Product Enhancement

N921052-3000 Unwelded C.V. Shaft Assembly
Replaces N921052-2600

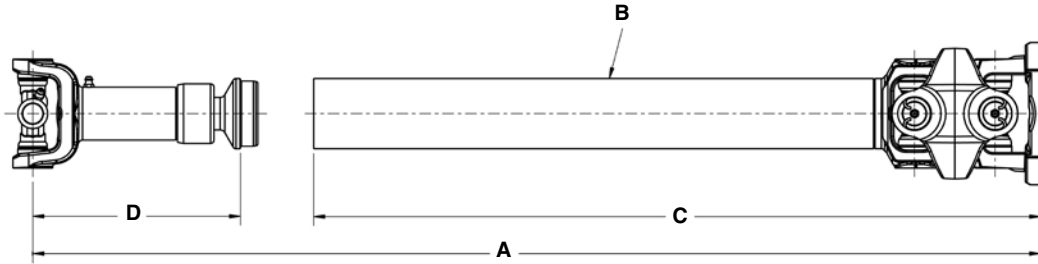
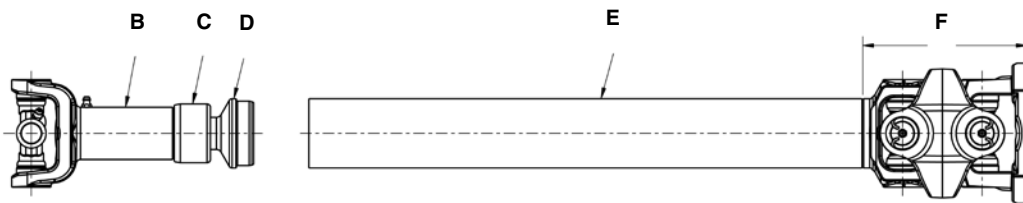
① Note: The tubing has been lengthened 4 inches to accommodate: lifted F-Series Trucks; lifted SUV's; and long wheelbase F350's.
